STAFF REPORT

Community Planning and Preservation Commission Certificate of Appropriateness Request

CITY FILE NO.: 21-90200008

After-the-Fact COA. Request for approval of as-built conditions relating to new construction at 736-18th Avenue NE. The as-built conditions deviate from several conditions of approval, for which the applicant is now requesting a modification or compliance waiver.

Appendices, Page 10 of 52:

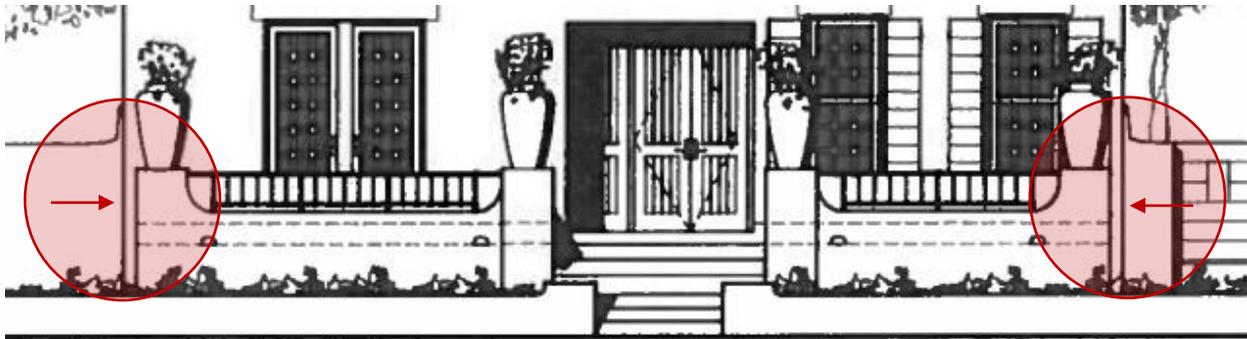
The red arrows show a break line delineating the main house from the recessed wall, consistent with the submitted (and now approved) site plan and color rendering.

Appendices, Page 12 and 13 of 52:

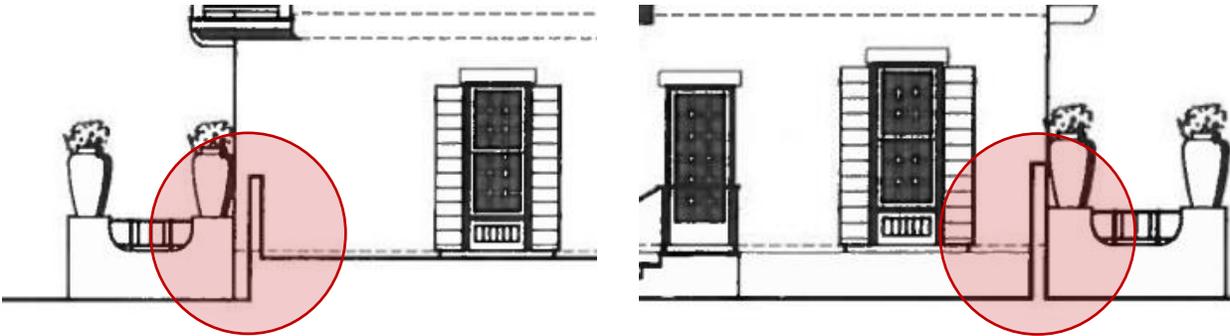
The applicant has rightfully pointed out that the wall location on this plan drawing (east elevation) is flush with the front plane of the house, but continues to be refuted by the associated reports and all other plans in the permit set as highlighted in this memorandum.

Color Rendering:

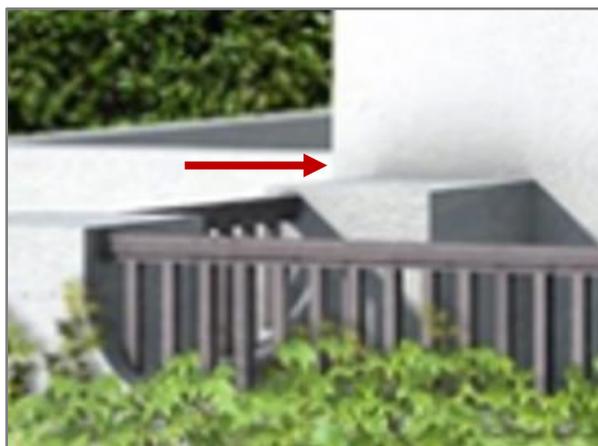
In addition to the elevations, the color rendering submitted with this COA application includes shading to appropriately delineate between the front plane of the house and the recessed wall.

Cropped color elevation.

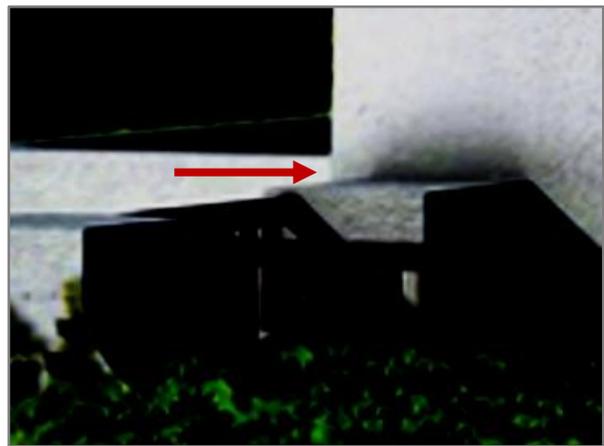
Cropped color elevation with adjusted brightness (-40%) and contrast levels (75%) to show hard shade line at corner.

Sheet A3 Rear and Left Elevation:

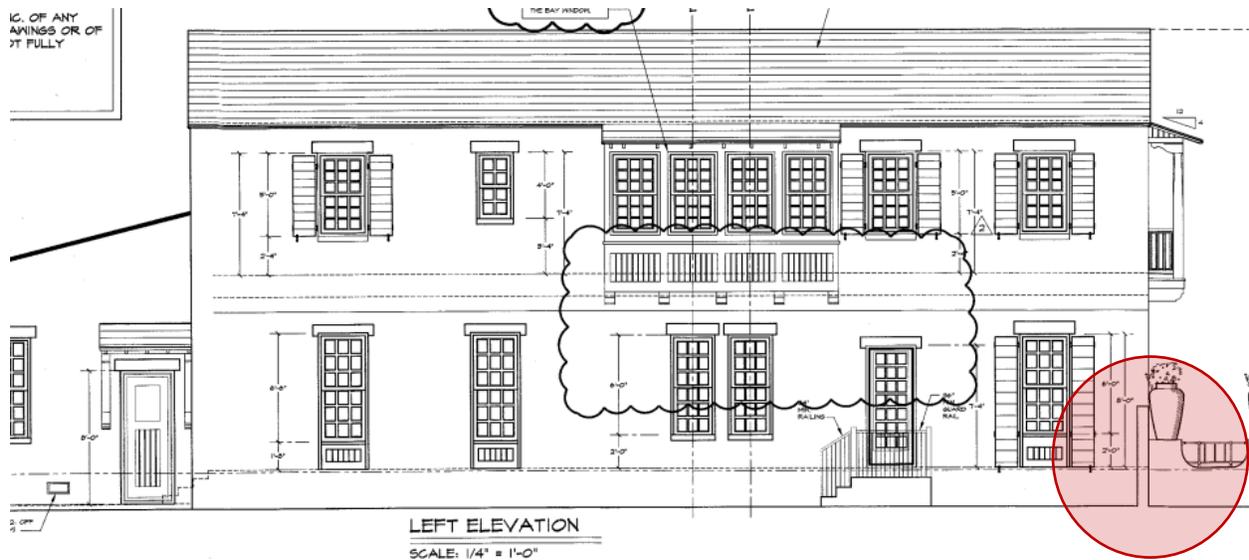
As noted earlier, this plan drawing (east elevation) is flush with the front plane, but continues to be refuted by the associated reports and all other plans in the permit set as highlighted in this memorandum.

Revision Memorandum
Prepared by Derek Kilborn
Dated October 24, 2019

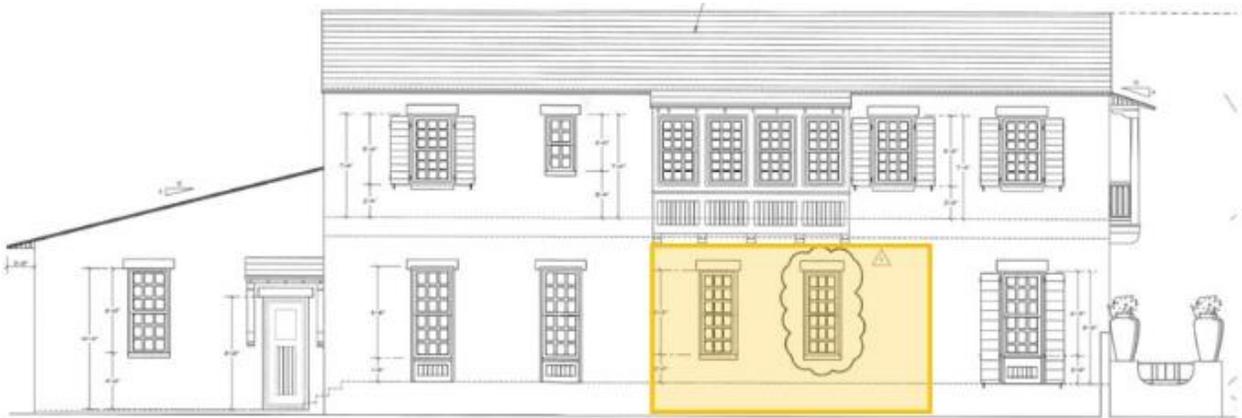
On October 19, 2018, historic preservation staff provided plan review comments on NSFR permit application 18-08001081, noting that the fenestration at the building's east elevation did not match the application which had been approved by the CPPC, upheld by City Council, and then challenged in Court by an immediate neighbor.

The inconsistency of the fenestration at the east elevation was determined to constitute a substantial design change from the plans as submitted during the COA application. City staff concluded that the proposed change from the originally approved plans created a misalignment between first- and second-floor openings that detracted from the overall rhythm required by the subject property's proposed Monterey-inspired design. The plan review was returned to the applicant for correction accordingly.

Under a later resubmission, the proposed fenestration at the east elevation was shown to have reverted to the original design approved under COA 18-90200016. City staff approved this change on September 13, 2019. Finally, on October 22, 2019, the applicant submitted another request to revise the fenestration at the east elevation, which was administratively approved by City staff and further described in a *Revision Memorandum* dated October 24, 2019.

Submitted to permitting on October 23, 2019

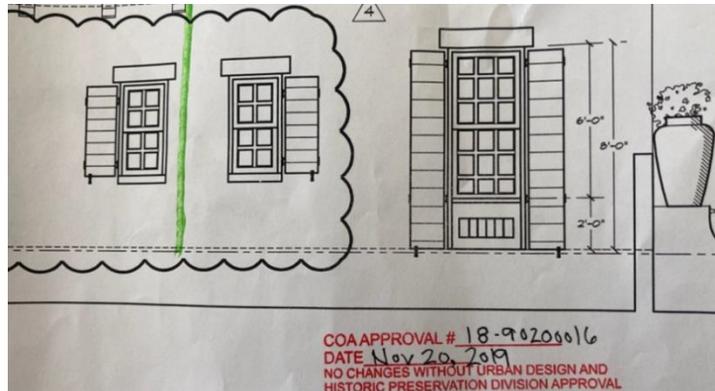
As noted by the applicant, this plan drawing (east elevation) is flush with the front plane of the house, but continues to be refuted by the associated reports and all other plans in the permit set as highlighted in this memorandum. The revision and approval stamp in the example below was for the plan change inside the bubble.

**Email from Richard McGinnis to Laura Duvekot
Dated March 27, 2020**

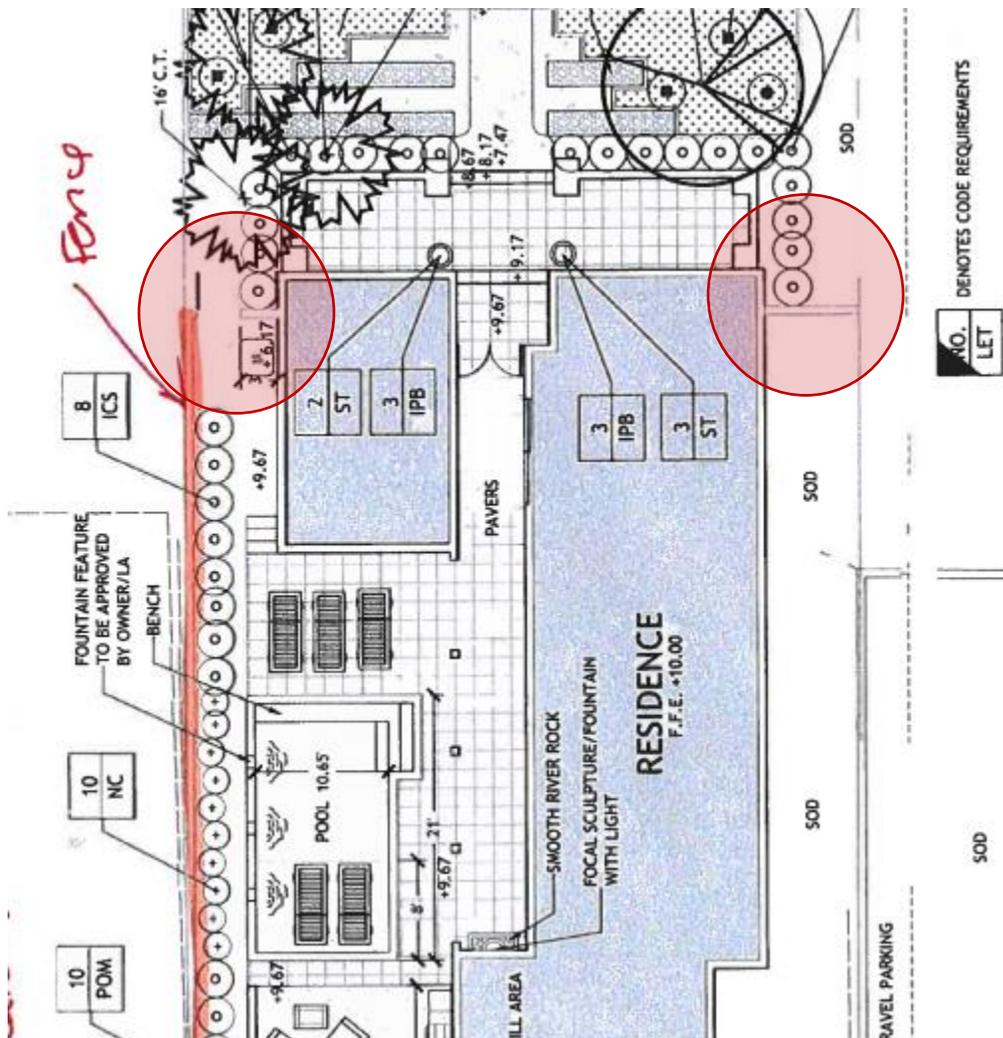
Perhaps the most significant evidence relating to the wall off-set and gate is a document emailed from the applicant to our Division as *recently* as March 27, 2020. The email attachment clearly shows the approved wall locations with a gate and wall off-set from the front plane of the house.
